PRELIMINARY SITE GRADING CONSTRUCTION PLANS
FOR
CREEKSIDE AT LORSON RANCH FILING NO. 1
EARLY GRADING / EROSION CONTROL PLANS

**COVER SHEET
EARLY GRADING AND
EROSION CONTROL PLAN**

DATE: AUGUST, 2018
 PROJECT NO. 100.045
 SHEET NUMBER C4.1
 TOTAL SHEETS: 17

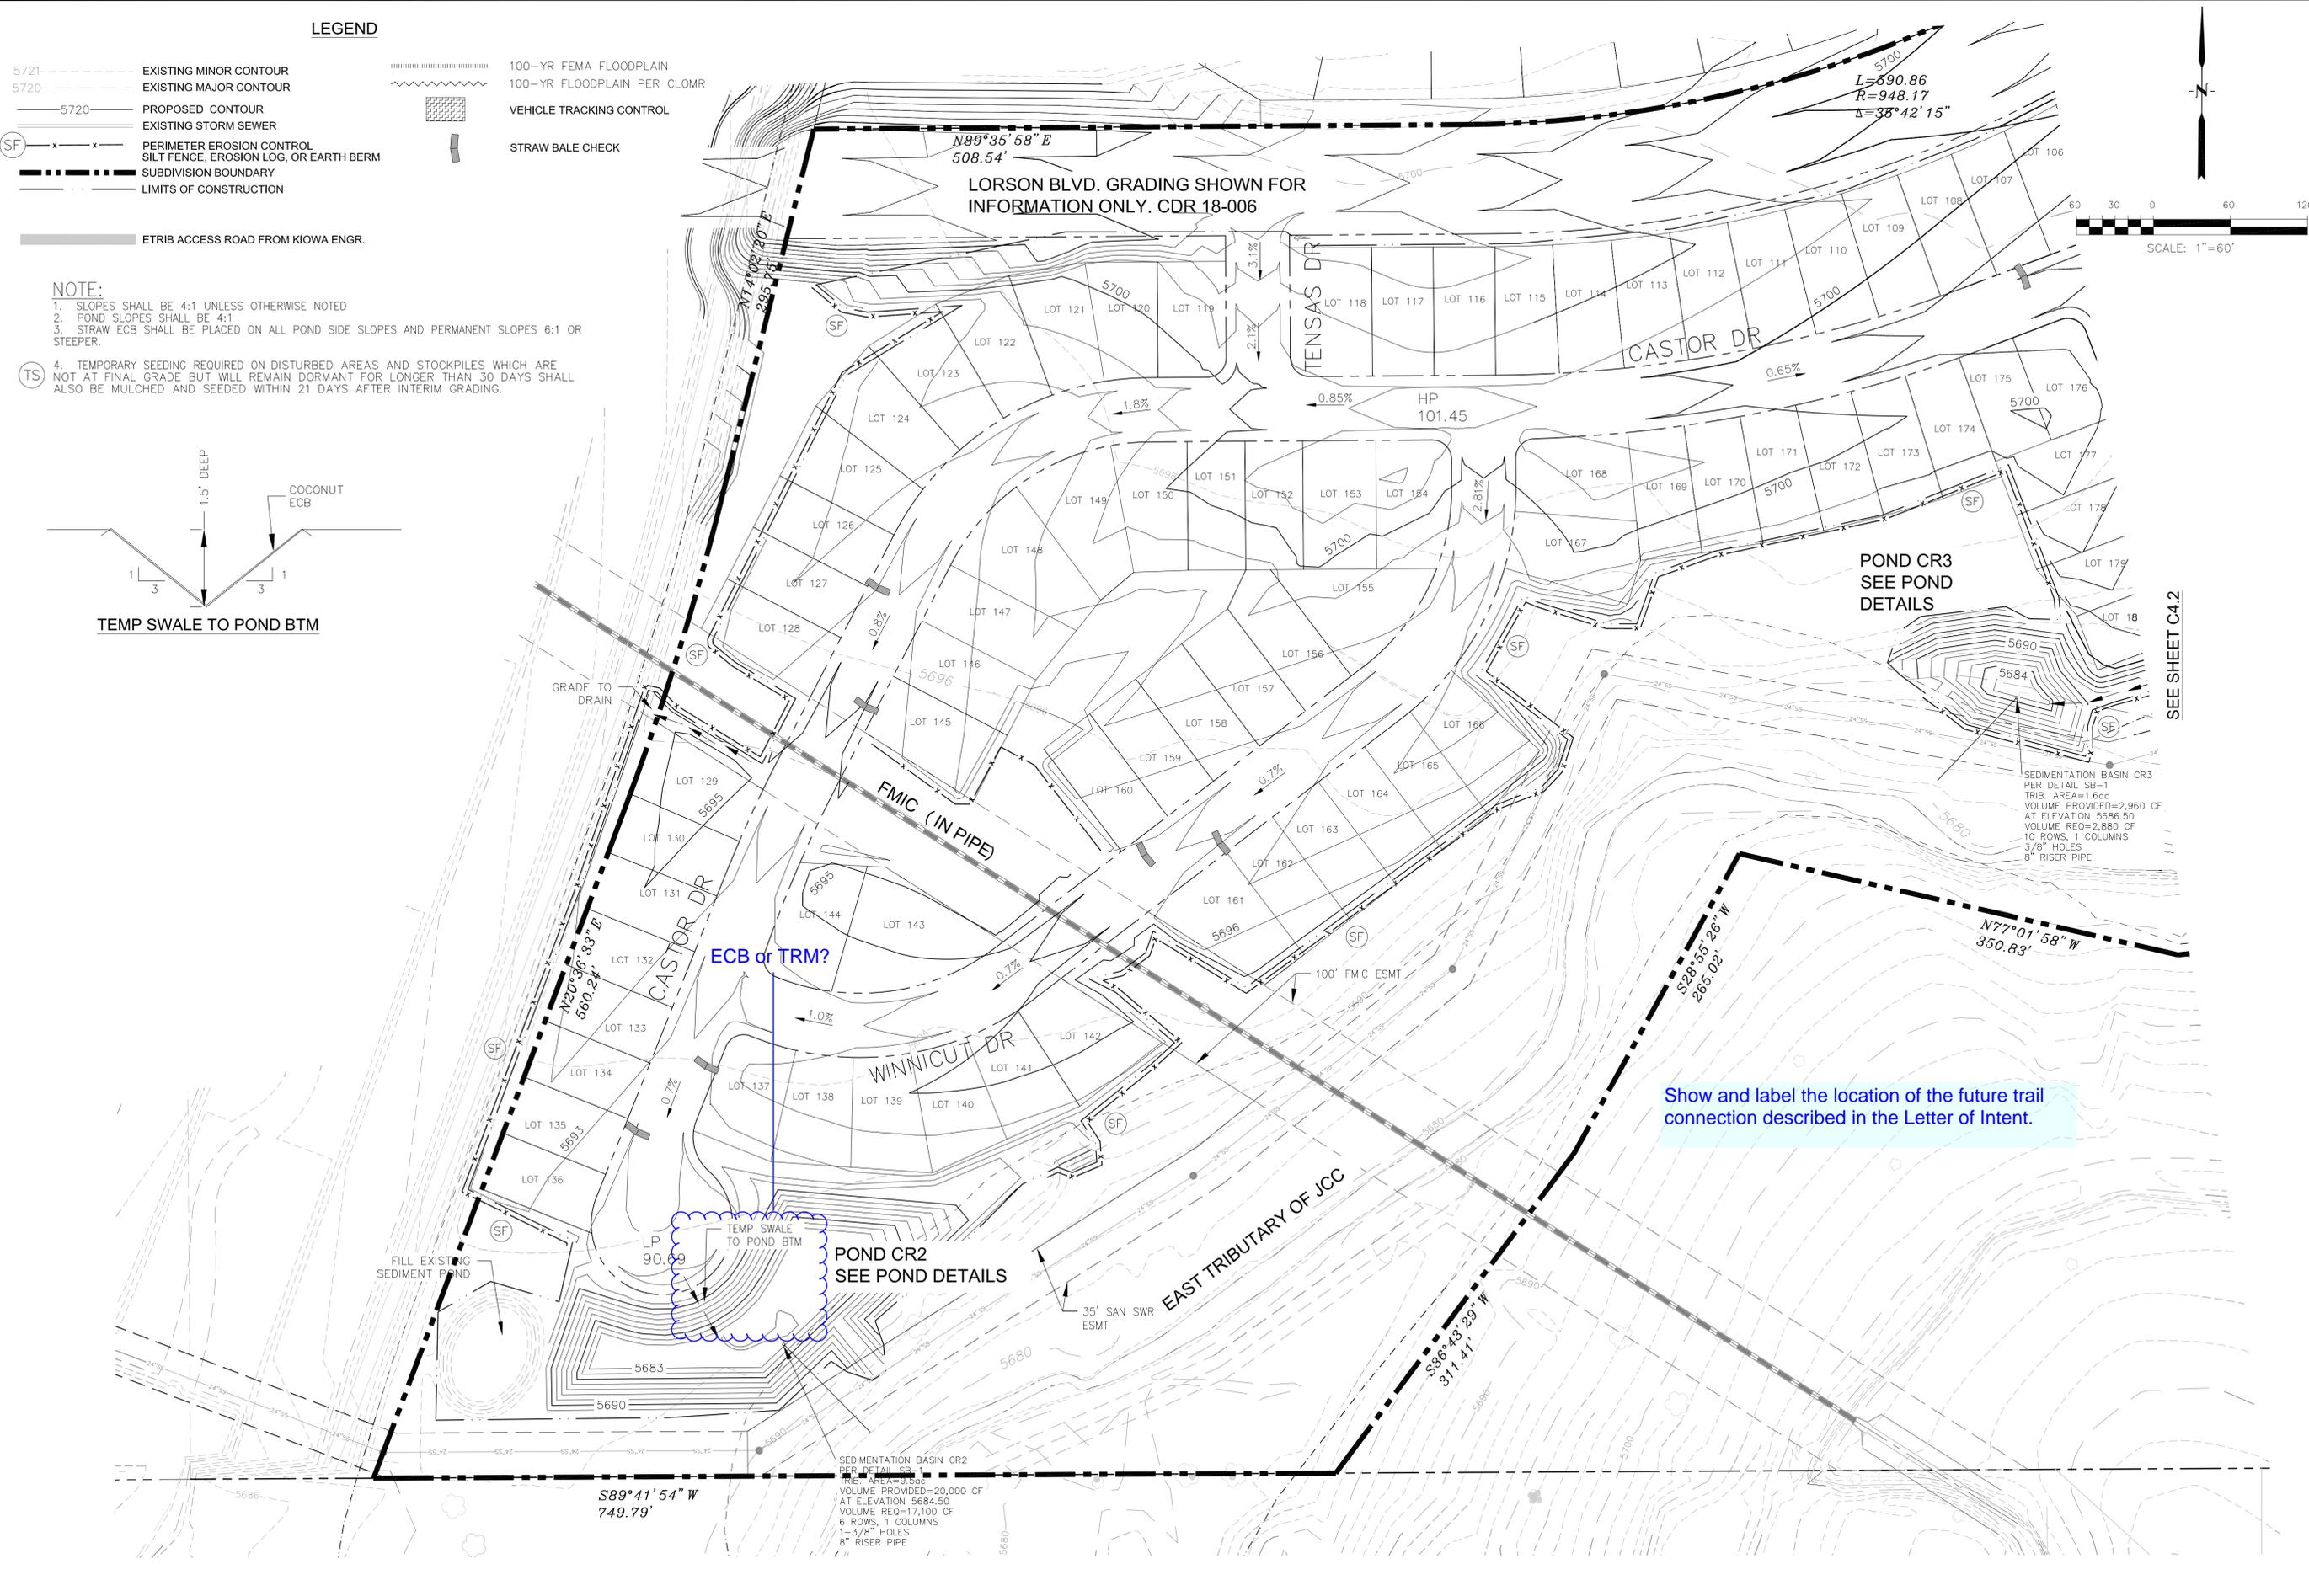
Show and label the location of the future trail connection described in the Letter of Intent.

DATE: AUGUST, 2018
PROJECT NO. 100.045
SHEET NUMBER **C4.2**
TOTAL SHEETS: 17

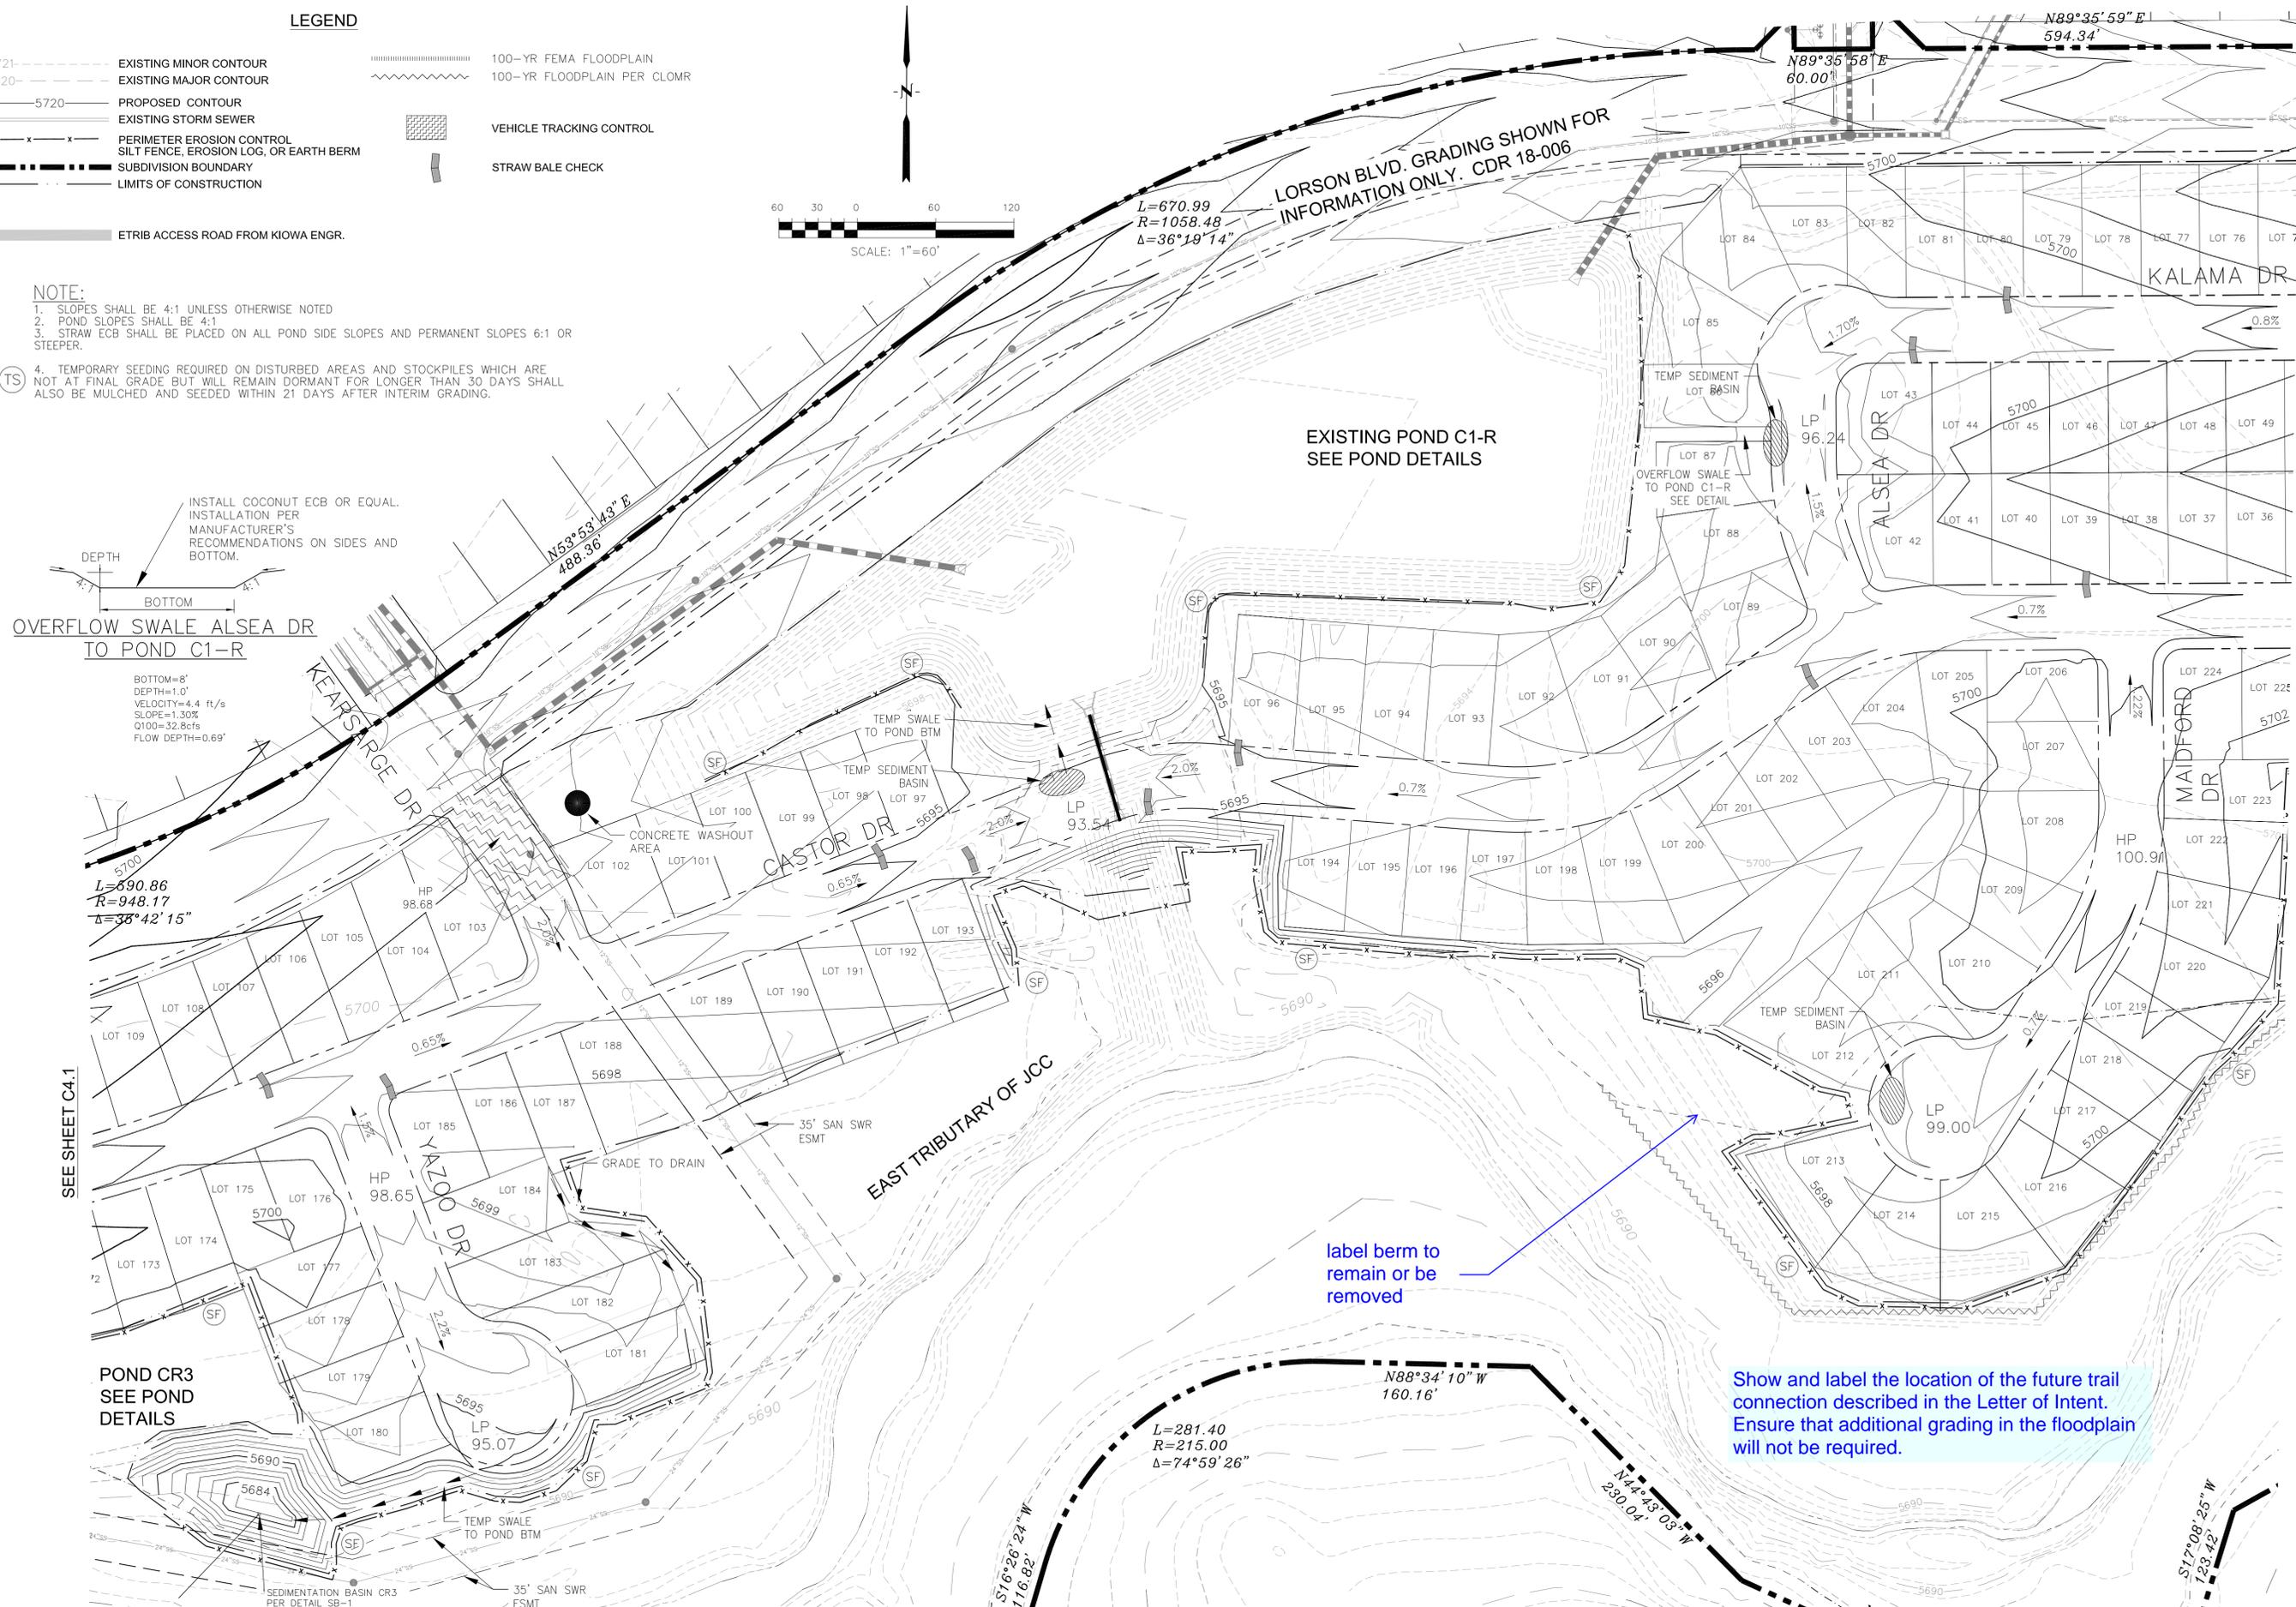
label berm to remain or be removed

Show and label the location of the future trail connection described in the Letter of Intent. Ensure that additional grading in the floodplain will not be required.

DATE: AUGUST, 2018
 PROJECT NO. 100.045
 SHEET NUMBER **C4.3**
 TOTAL SHEETS: 17

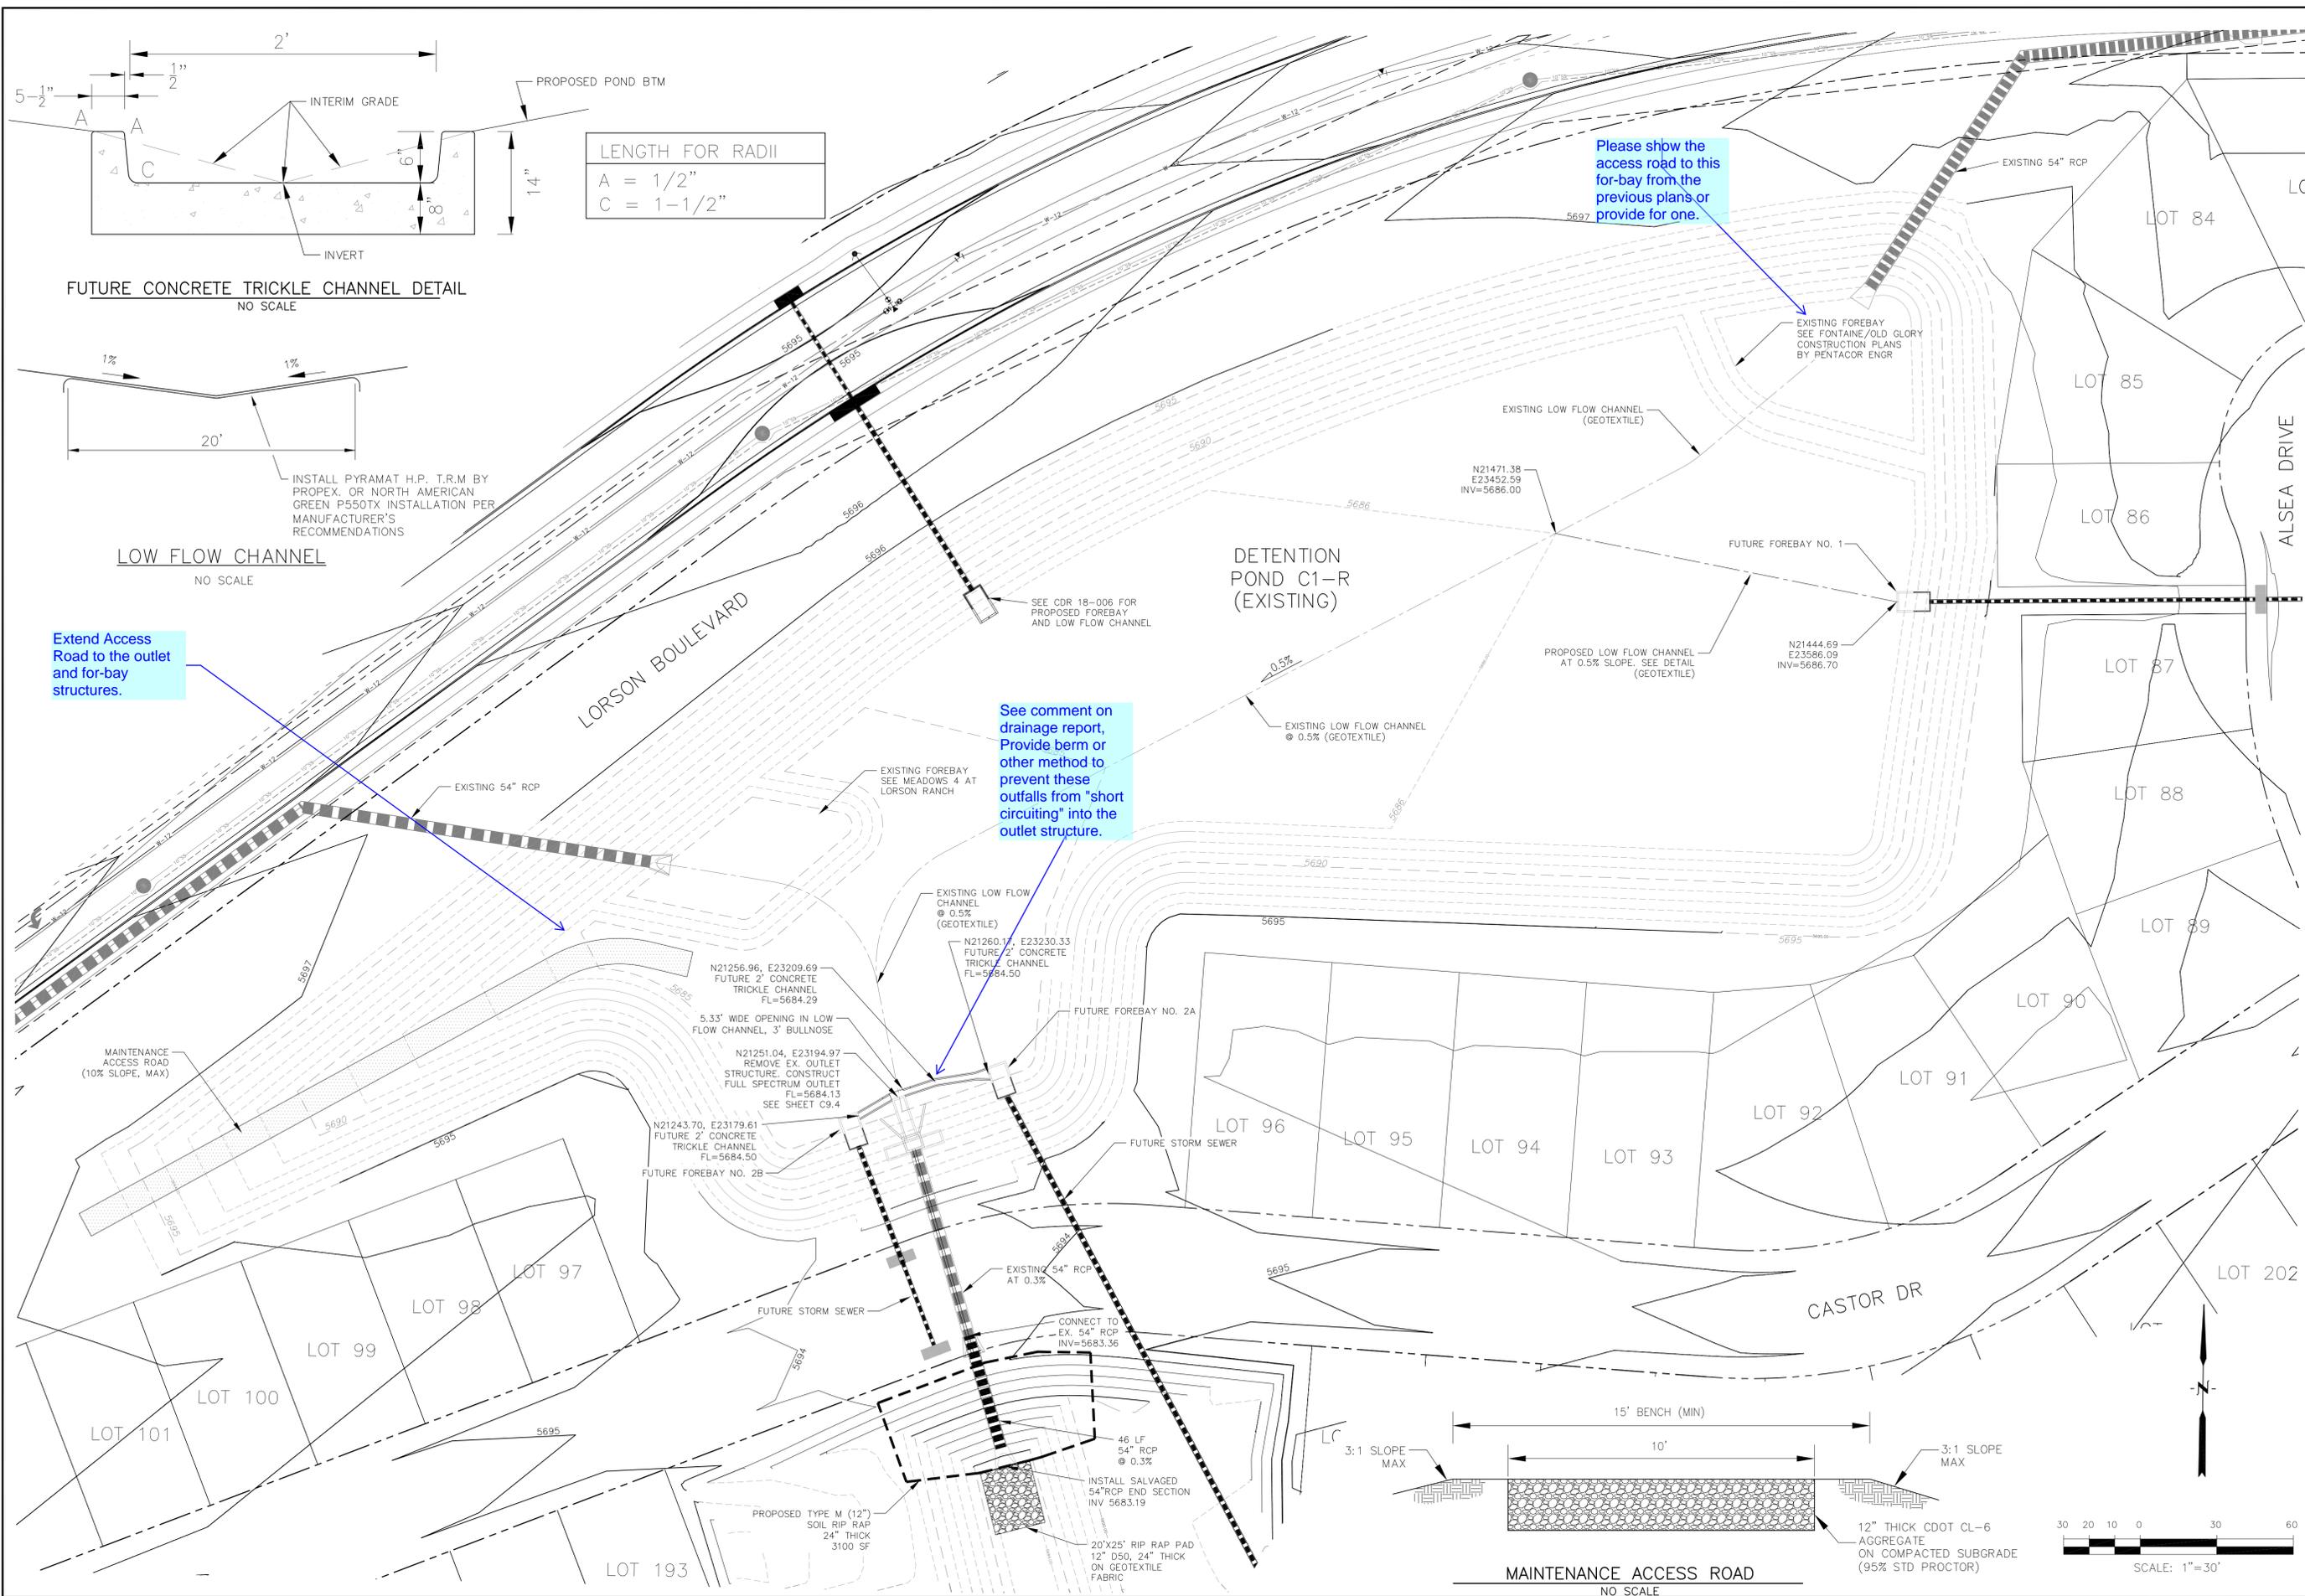
Extend Access Road to the outlet and for-bay structures.

See comment on drainage report, Provide berm or other method to prevent these outfalls from "short circuiting" into the outlet structure.

Please show the access road to this for-bay from the previous plans or provide for one.
